MIL-M-38510/504A(USAF)
AMENDMENT 3
10 NOVEMBER 1996
SUPERSEDING
AMENDMENT 2
11 SEPTEMBER 1986

MILITARY SPECIFICATION

MICROCIRCUITS, DIGITAL, BIPOLAR PROGRAMMABLE LOGIC, MONOLITHIC SILICON

FIGURE 8a. Programming waveforms for circuit A.

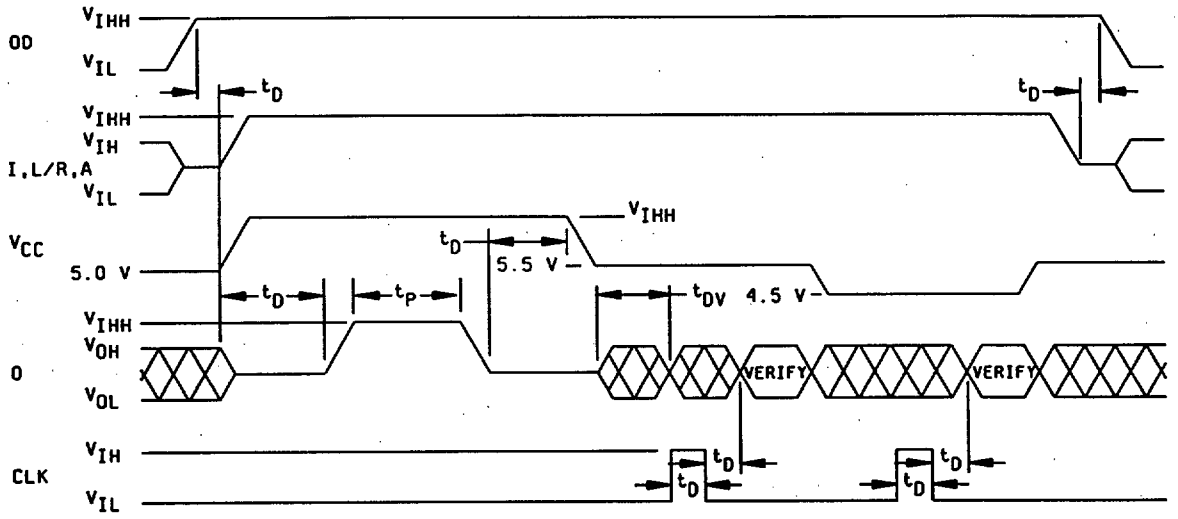
"4.6 Programming/verifying procedure for circuits A, B, and C. The programming specifications on figure 8a, figure 9, and table IV for circuit A; figure 8b, figure 9, and table V for circuit B; and figure 8c, figure 9, and table VI for circuit C, and the following procedures shall be used for programming the device."

"e. Pulse the CLOCK pin and verify (with CLOCK at V_{IL}) that the output pins, O0 through O3, are in the state corresponding to an unblown fuse. Use the minimum timing conditions as specified on figure 8a for circuit A, figure 8b for circuit B, and figure 8c for circuit C.
- For verified unblown condition, continue procedure from C through E.
- For verified blown condition, stop procedure."

"f. Program the fuse by pulsing the output pins of the selected group -one at a time- to V_{IHH}, see figure 8a for circuit A, figure 8b for circuit B, and figure 8c for circuit C."
